**CONWAY**  
HISTORIC DISTRICT COMMISSION  
**FEBRUARY**

## **CONWAY HISTORIC DISTRICT COMMISSION MEETING**

**OLD CONWAY DESIGN OVERLAY DISTRICT  
CERTIFICATE OF APPROPRIATENESS REVIEW  
DAVIS GARAGE EXTENSION AT 1828 LEE AVENUE**

**OLD CONWAY DESIGN OVERLAY DISTRICT  
CERTIFICATE OF APPROPRIATENESS REVIEW  
BRYAN OUTBUILDING/FUTURE RESIDENCE  
1215 NORTH ASH STREET**

SIDE ELEVATION

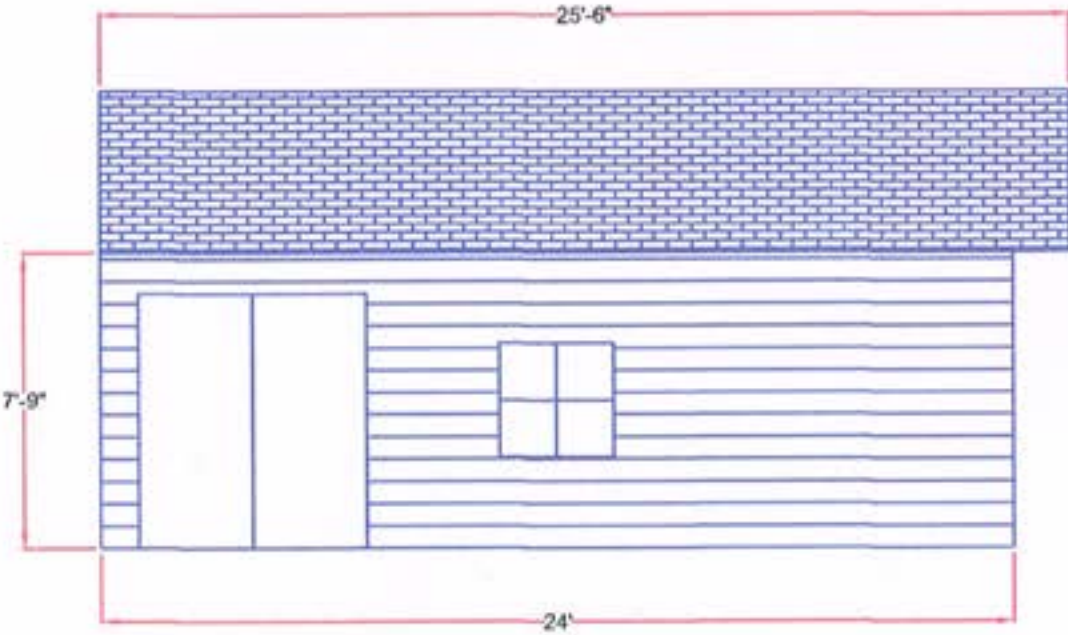
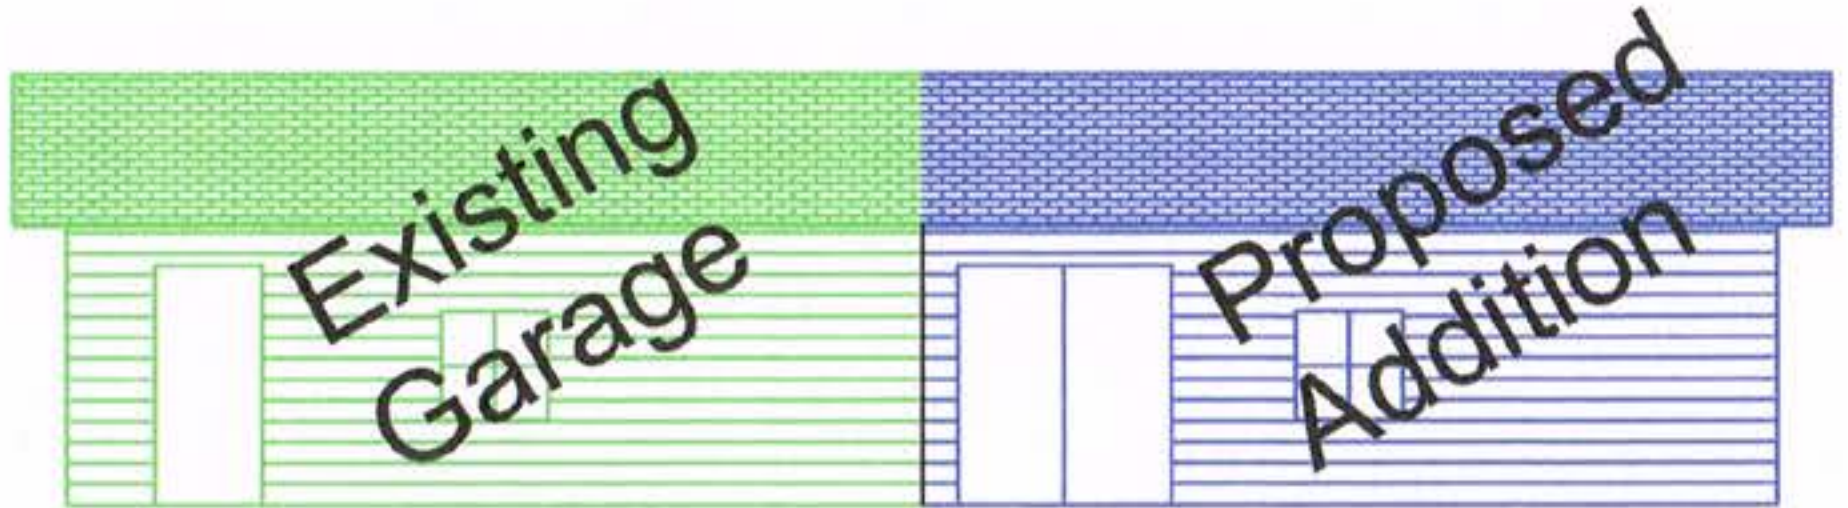
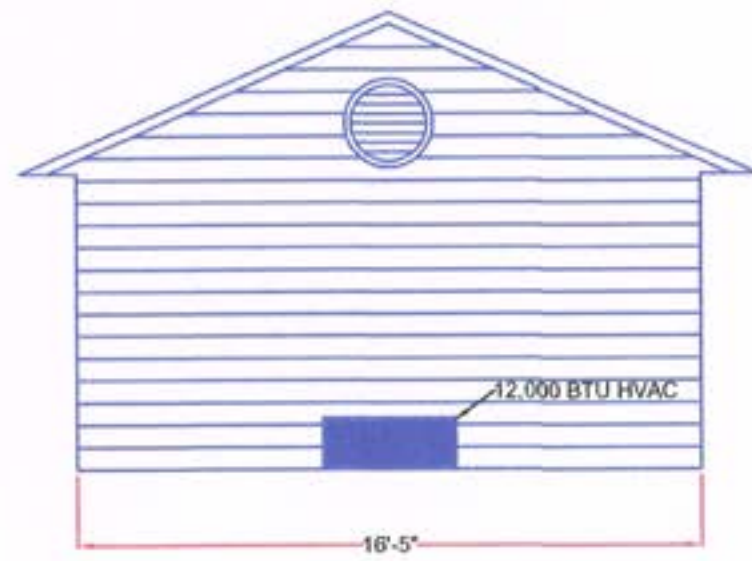
**Directional expression.** Measurement of the height to width ratio of a structure's elevation. The height/vertical expression of the garage becomes more horizontal. However, the deeper extension is not seen from the street. The appearance of the existing garage from the street will not change.

**Facade, wall area, rhythm.** Facades shall be compatible with surrounding historic structures in proportion of wall to opening area. The garage is utilitarian in nature and largely unseen by the public. A sliding patio door and window will be added to the east elevation. The alley and rear sides will have no windows or doors, but are unseen.

**Doors and windows.** The size and proportion, or the ratio of width to height of window and door openings of new buildings' primary facades should be similar and compatible with those on facades of surrounding historic homes. A window and door are shown on the east yard side of the structure. The garage's front facade remains unchanged. No additional doors or windows are proposed, however, the rear and west side elevations are not visible from the public realm or abutting neighbor's yard.

**Architectural Details, Siding, and Bricks.** Eaves, brackets, dentils, cornices, molding, columns, trim, etc. Architectural detail proposed on a new residential structures should be compatible with existing elements, in style, material, size, and shape. The existing garage has minimal detailing. The extension will match the same level of detailing. A vinyl siding matching the existing residence and garage is proposed.

1. The garage extension shall be constructed as shown in submitted plans.
2. The existing garage and extension is allowed to have a 0 foot side setback (west side against unbuilt alley right of way).
3. Vinyl siding material shall be allowed to match existing garage and residence.
4. HVAC and utility equipment shall be appropriately located at the rear of the garage extension.

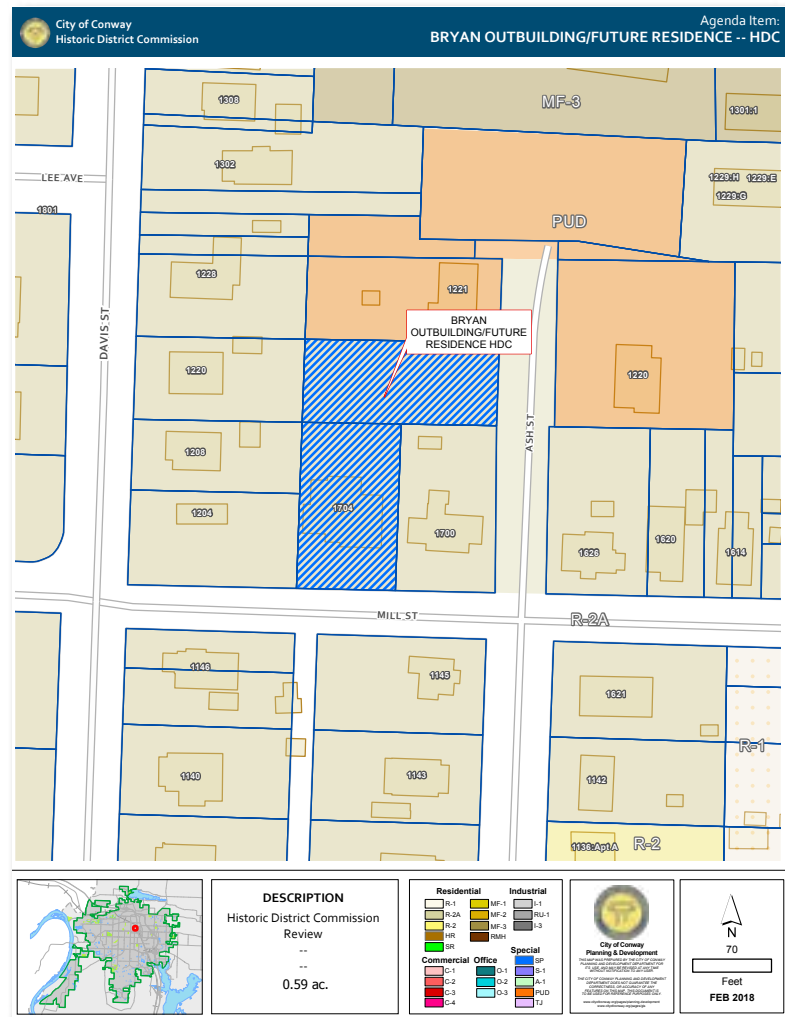
**Setbacks.** Proposed setbacks should respect the predominant setbacks of area structures, especially the front setback. Front setbacks are allowed within a range of 85% to 115% of the average area front setback. There is only one residence on North Ash Street at 22 feet from the property line. The proposed front setback is approximately 19.6 feet from the property line to the porch overhang. The north side setback is shown at 6 feet and the south setback from the roof overhang to the property line is shown at 5 feet. The proposed setbacks are appropriate.

**Driveway/Parking/Carport.** Two driveways are proposed. On the north, a 11' wide x 30' foot long patio block or permeable driveway is proposed. On the south side a 15' x 30' driveway is proposed to access the RV covered area. This drive extends back the length of the RV cover area.

**Tree preservation.** The submitted plans show the removal of a pecan tree on the south side and an oak, locust, and hackberry on the north side. There are also some fig trees that will be replanted. The structure is placed to avoid removal of a persimmon tree.

**Setbacks -** The structure's proposed setbacks approximately as measured from the property line: front - 19.6 feet, north 6 feet, south 5 feet, and rear 100 feet+ seem appropriate.

EAST ELEVATION

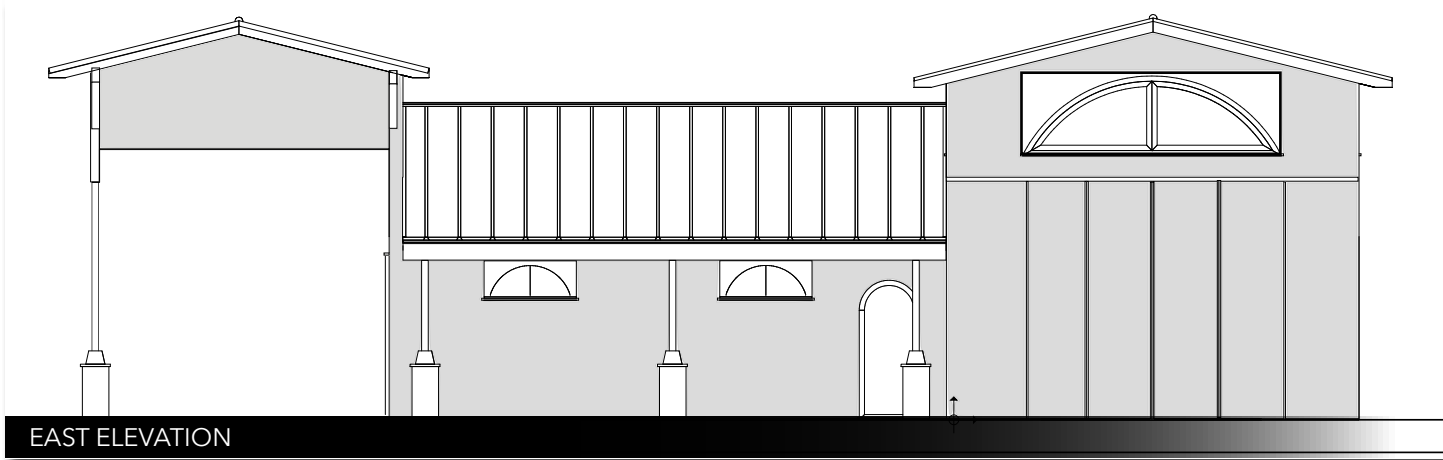
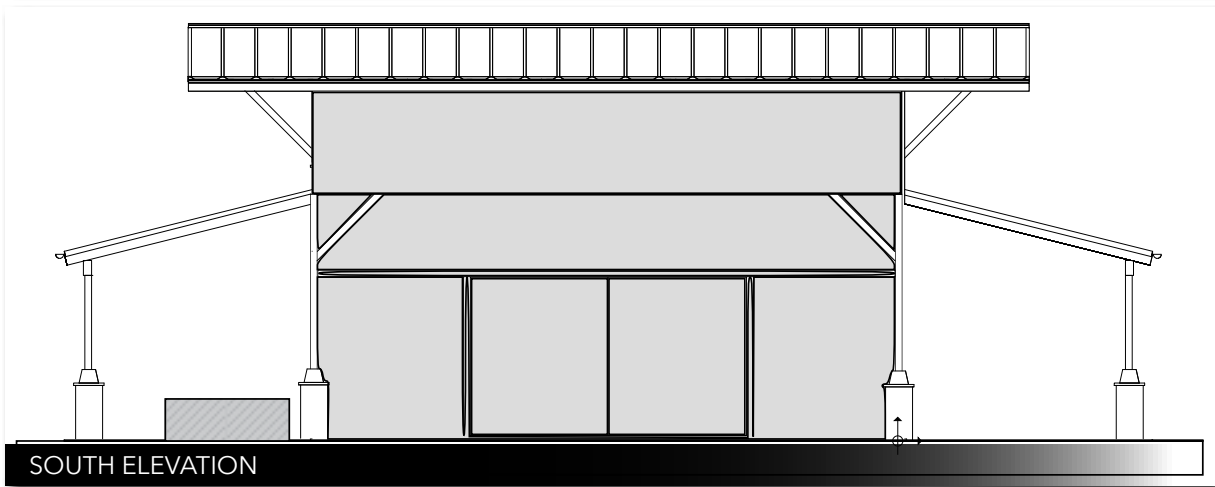
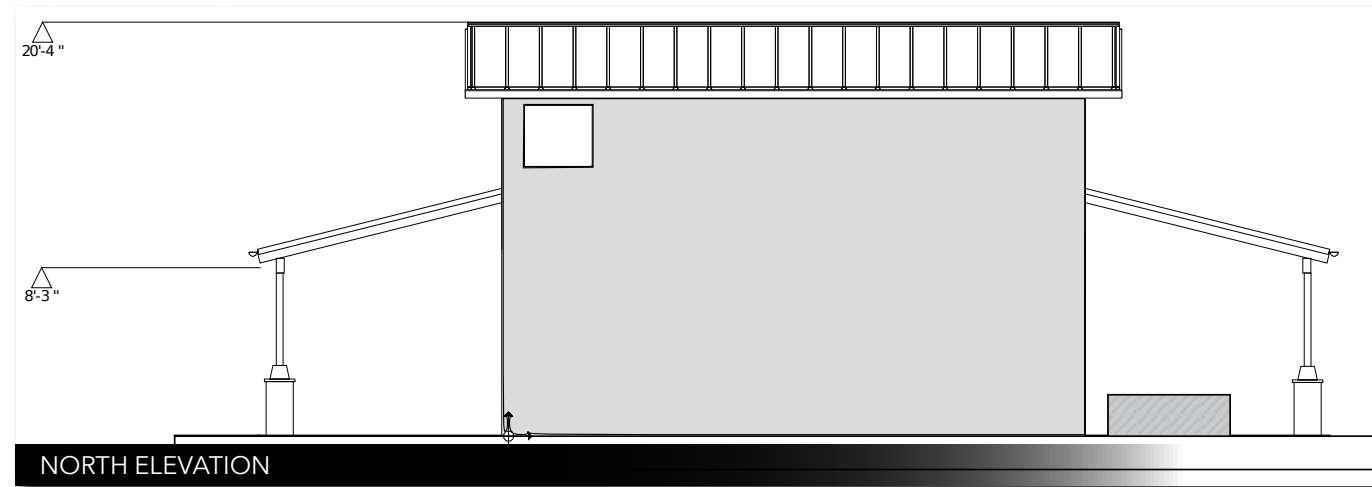
**Scale.** The size of new construction in relation to neighboring structures and the proportion of structures to the human scale. The new structure's overall scale is diverse. The overall size in comparison to neighboring structures is proportional, however the relation to the human scale is disproportionate. The size and heights of doors, windows, open areas, eave lines, etc do not relate well with the human scale.

**Height.** The average height of area structure's eaves and cornices. Also, the first floor elevation / height relationship. The outbuilding is initially planned to be one story. However, the north side of the structure will be sufficiently tall to allow construction of a second floor in the future as a residence. The eave peak of the south RV cover and the north 2 story section is around 20'-4". The overall height will likely blend with other area one story structures as there is sufficient distance between structures. The differences in eave heights seems emphasized by the lower eaves and lower peak of the middle section's roof in comparison to the high roofs. It appears that the majority of the structure will have a tall interior ceiling. It is unclear what the initial and ultimate first floor to ceiling height will be. The height of the open carport seems disproportionate as it allows for RV storage.

**Facade, wall area, rhythm.** Facades shall be compatible with surrounding historic structures in proportion of wall to opening area. The structure has few windows and doors. As a shop structure, this could be seen as appropriate. If used as a residence, additional windows should be added. The applicant has indicated that additional windows would be placed under the arched transom windows and the large garage doors would be replaced with windows when the structure is converted to a residence.

**Doors and windows.** The size and proportion, or the ratio of width to height of window and door openings of new buildings' primary facades should be similar and compatible with those on facades of surrounding historic homes. An arched doorway is shown on the front facade. The arched door is described as; salvaged arched wooden doors with windows, already acquired. Arched transom windows are shown on the front face middle section and 2 story section. These are described as windows with painted PVC trim. The applicant intends to add additional windows under the arched windows and in the large door locations if the structure were remodeled into a residence. A large carport door is shown on the south elevation and described as; sliding doors covered with vinyl siding. A large tall door is shown on the two story section's front facade and described as; double overlapped sliding doors covered with vinyl siding.

**Garage Generally.** The OCDOD standards prefer detached garages at the rear of residences. If attached garages should be at least 1/2 the depth between the front and rear facades. As a garage outbuilding, a large garage door on the front facade could be seen as appropriate. However, as a residence, this should not be a primary front facade feature. The applicant indicates that the large garage doors would be replaced with windows if the structure were converted to a residence.

**Architectural Details, Siding, and Bricks.** Eaves, brackets, dentils, cornices, molding, columns, trim, etc. Architectural detail proposed on a new residential structure should be compatible with existing elements, in style, material, size, and shape. The structure has little detailing. Metal welded 45 degree bracket supports are shown on the tall carport eave. Exposed rafter tails are shown. The applicant describes rafter details as; Exposed beams will be built up from lumber. If fascia boards not used on rafter ends, then a small piece of thin material will be used to cap the end grain and trimmed to rafter end dimensions. The underside of eaves/gables are described as covered with planks or bead board above exposed rafters. Underside of porch either has ceiling or planks/bead boards above exposed rafters.

1. The overall scale and massing of the structure
2. Details such as windows, doors, column design, etc
3. Floor to ceiling heights
4. Siding material
5. Roof material
6. HVAC and utility equipment locations
7. Sidewalk in-lieu fee
8. Possible future review prior to residence conversion
